LANDING GEAR - LANDING GEAR WARNING HORN REPLACEMENT

The original landing gear warning horn is no longer available. If the landing gear warning horn needs to be replaced, a new landing gear warning horn is available and will require an additional bracket for installation.

MEB-32-01
Page 1 of 25

Figure 1. 310Q Before Modification (Sheet 1)

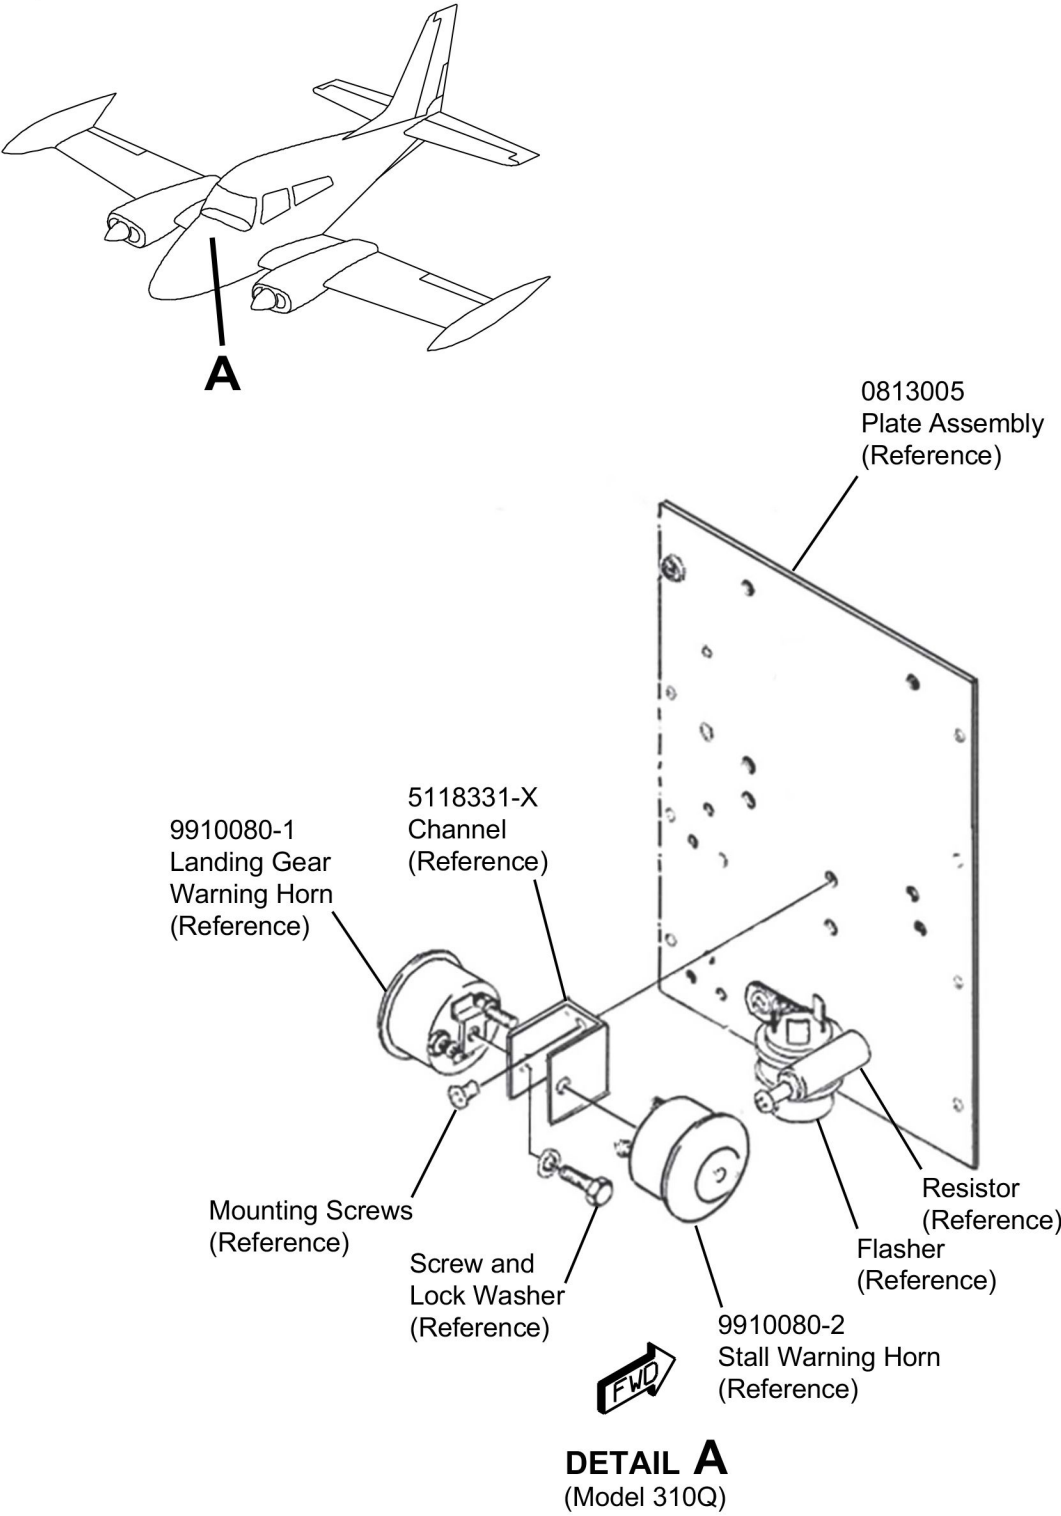
3. (For Model 310Q Refer to Figure 1, Sheet 1, and for Model 310R Figure 2, Sheet 1.) Remove the 9910080-1 Landing Gear Warning Horn as follows:
- A. Remove and discard the screw and lock washer from the 9910080-1 Landing Gear Warning Horn.

- B. Disconnect and label the electrical wiring from the 9910080-1 Landing Gear Warning Horn.
 - C. Discard all electrical hardware from the 9910080-1 Landing Gear Warning Horn.

Figure 3. 310Q Configuration 1 (Sheet 1)

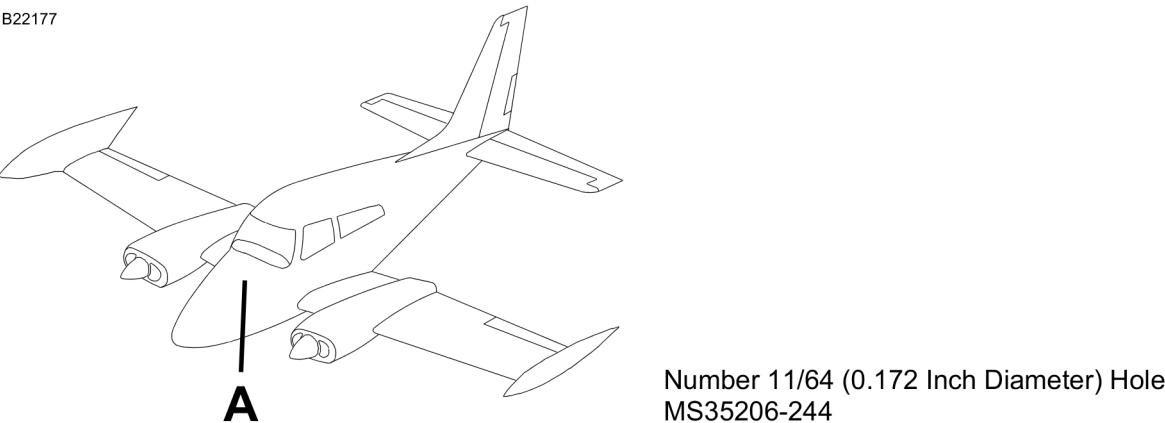
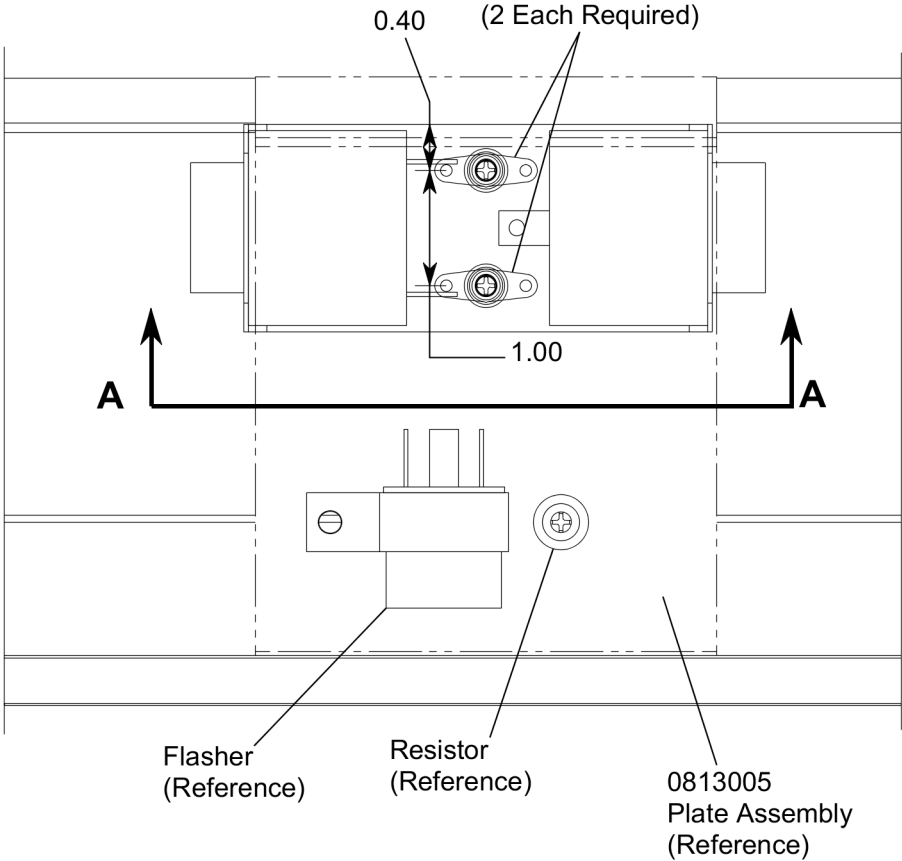
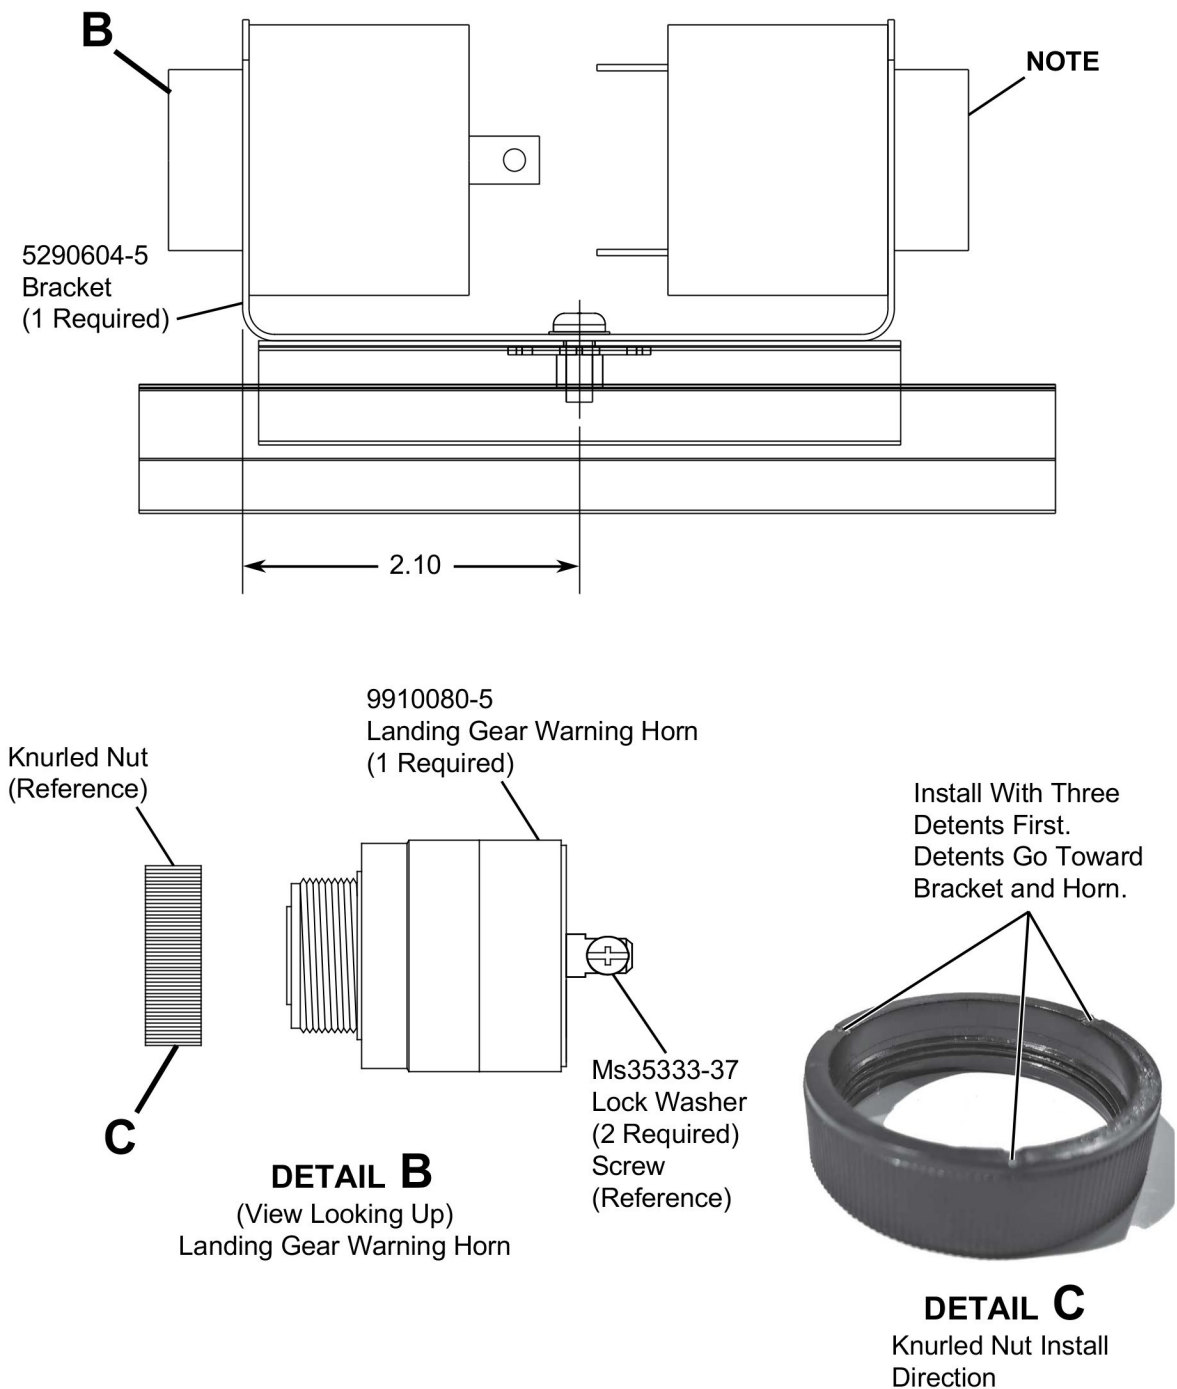
- J. Discard the 5118331-X Channel.
4. (For Model 310Q Refer to Figure 3, Sheet 1 and 2, and for Model 310R Figure 4, Sheet 1 and 2.) Install the 9910080-5 Landing Gear Warning Horn as follows:

- A. (For Model 310Q airplanes.) Match drill the two Number 11/64 (0.172 inch diameter) holes of the 0813005 Plate Assembly to the 5290604-5 Bracket.
 - (1) Deburr the drilled holes from the 5290604-5 Bracket.
 - (2) Apply Color Chemical Film Treatment to all bare metal.
 - (3) Go to Step 4C.
- B. (For Model 310R airplanes.) Match drill the two Number 11/64 (0.172 inch diameter) holes of the 0818109 Support Assembly to the 5290604-5 Bracket.
 - (1) Deburr the drilled holes from the 5290604-5 Bracket.
 - (2) Apply Color Chemical Film Treatment to all bare metal.
- C. Install the 5290604-5 Bracket with the two MS35206-244 Screws and the two NAS1149FN816P Washers into the 0813005 Plate Assembly or the 0818109 Support Assembly.
- D. Install the 9910080-5 Landing Gear Warning Horn into the 5290604-5 Bracket.

- E. Install the knurled nut onto the 9910080-5 Landing Gear Warning Horn.

NOTE: The plastic knurled nut must be installed with the three indents toward the bracket and horn assembly. On the internal circumference, the smooth side without threads is installed first, towards the bracket and horn. This technique of installation will make sure the nut fully seats against the bracket and not bottom-out on the threads. If not installed correctly the knurled nut will bottom-out on the threads and the horn assembly will not be fully tightened in the bracket.

- F. Install the labeled electrical wiring, screws, and the two MS35333-37 Lock Washers into the 9910080-5 Landing Gear Warning Horn.

Figure 5. 310Q Configuration 2 (Sheet 1)

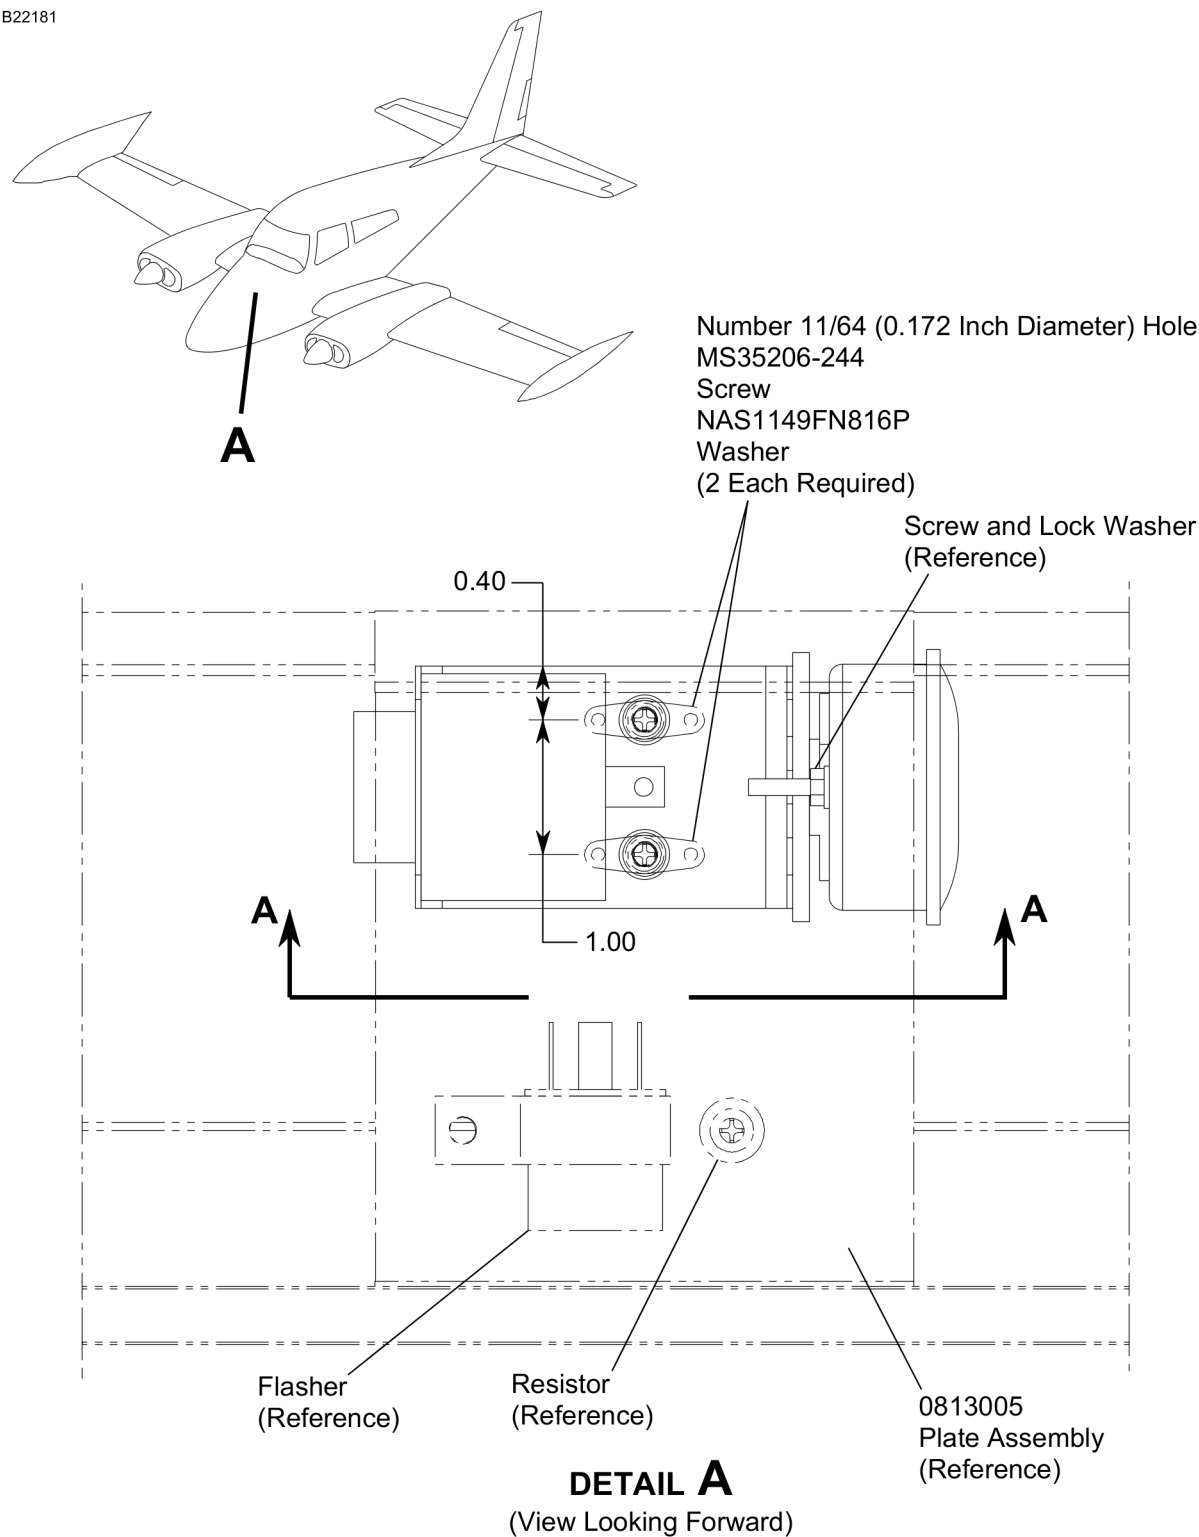
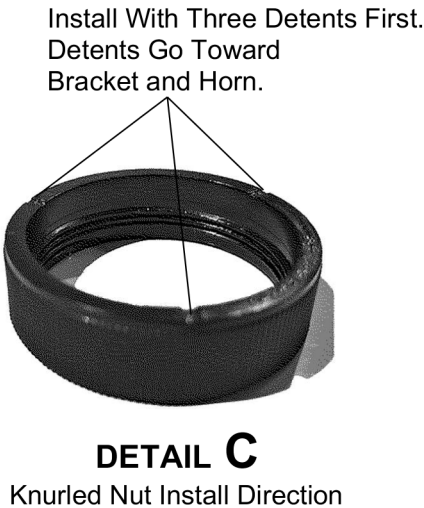
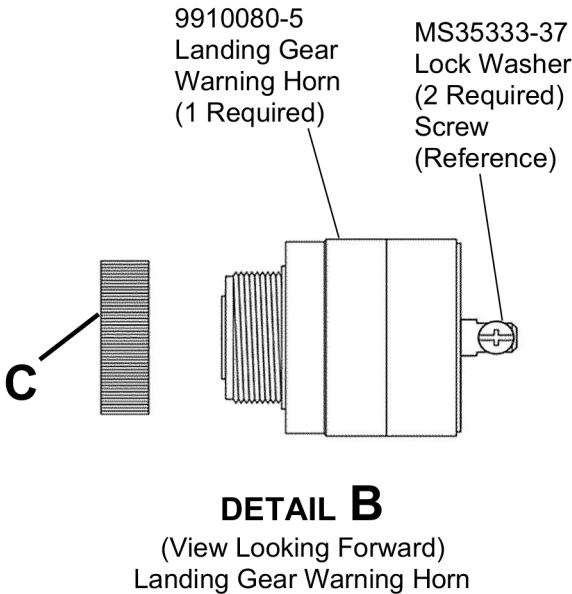
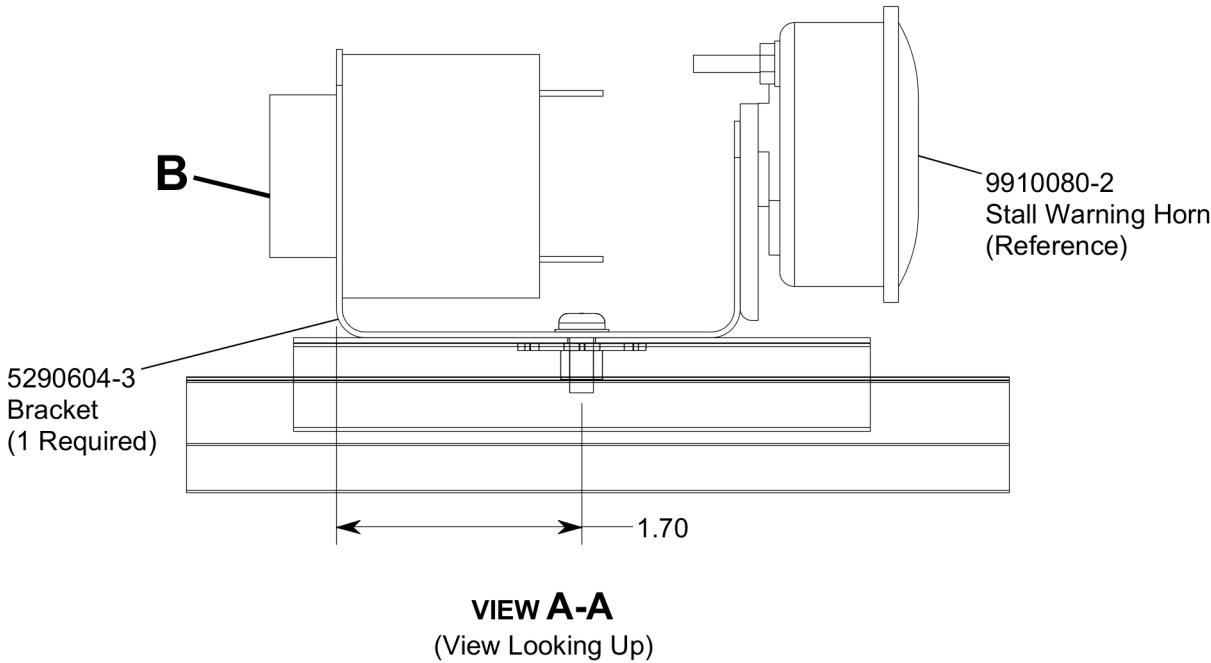
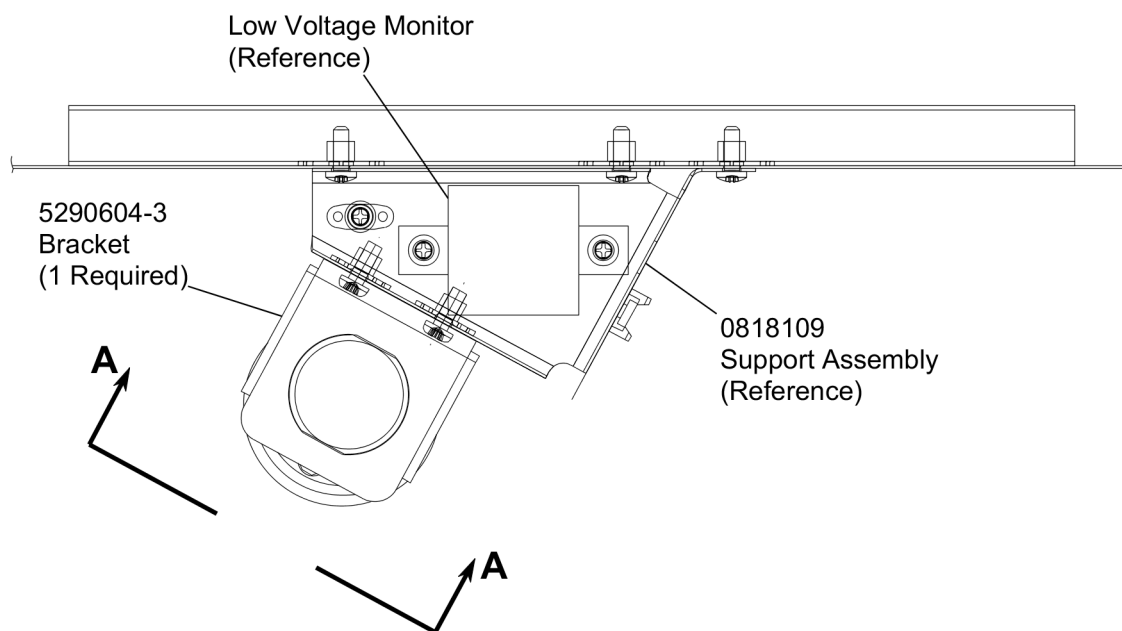
9. (For Model 310Q Refer to Figure 5, Sheet 1 and 2, and for Model 310R Figure 6, Sheet 1 and 2.) Install the 9910080-5 Landing Gear Warning Horn as follows:

- A. (For Model 310Q airplanes.) Match drill the two Number 11/64 (0.172 inch diameter) holes of the 0813005 Plate Assembly to the 5290604-3 Bracket.

(1) Debur the drilled holes from the 5290604-3 Bracket.

- (2) Apply Color Chemical Film Treatment to all bare metal.
- (3) Go to Step 9C.
- B. (For Model 310R airplanes.) Match drill the two Number 11/64 (0.172 inch diameter) holes of the 0818109 Support Assembly to the 5290604-3 Bracket.
 - (1) Deburr the drilled holes from the 5290604-3 Bracket.
 - (2) Apply Color Chemical Film Treatment to all bare metal.
- C. Install the 5290604-3 Bracket with the two MS35206-244 Screws and the two NAS1149FN816P Washers into the 0813005 Plate Assembly or the 0818109 Support Assembly.
- D. Install the 9910080-5 Landing Gear Warning Horn into the 5290604-3 Bracket.
- E. Install the knurled nut onto the 9910080-5 Landing Gear Warning Horn.

NOTE: The plastic knurled nut must be installed with the three indents toward the bracket and horn assembly. On the internal circumference, the smooth side without threads is installed first, towards the bracket and horn. This technique of installation will make sure the nut fully seats against the bracket and not bottom-out on the threads. If not installed correctly the knurled nut will bottom-out on the threads and the horn assembly will not be fully tightened in the bracket.
- F. Install the labeled electrical wiring, screws, and the two MS35333-37 Lock Washers into the 9910080-5 Landing Gear Warning Horn.

Figure 7. 310Q Before Configuration 3 Modification (Sheet 1)

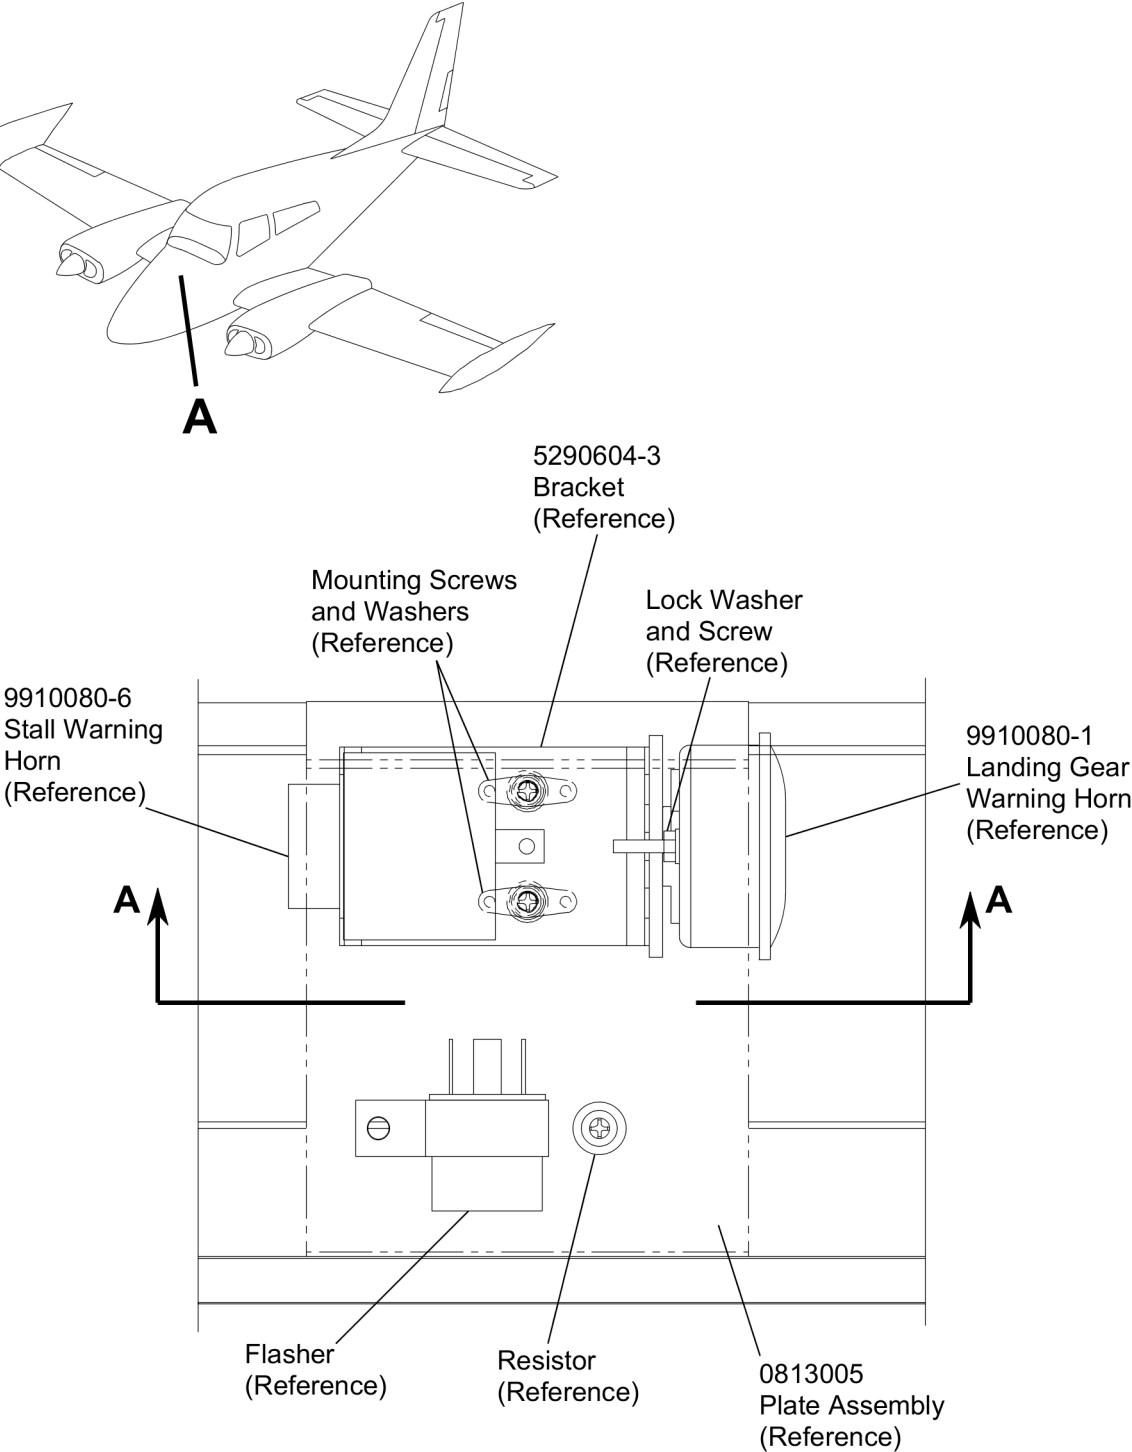
- 14. (For Model 310Q Refer to Figure 7, Sheet 1, and for Model 310R Figure 9, Sheet 1.) Remove the 9910080-1 Landing Gear Warning Horn as follows:
 - A. Remove and discard the screw and lock washer from the 9910080-1 Landing Gear Warning Horn.

- B. Disconnect and label the electrical wiring from the 9910080-1 Landing Gear Warning Horn.
- C. Discard all electrical hardware from the 9910080-1 Landing Gear Warning Horn.
- D. Discard the 9910080-1 Landing Gear Warning Horn.
- E. Remove and keep the 9910080-6 Stall Warning Horn.

- F. Remove and keep the two mounting screws and the two washers from the 5290604-3 Bracket.
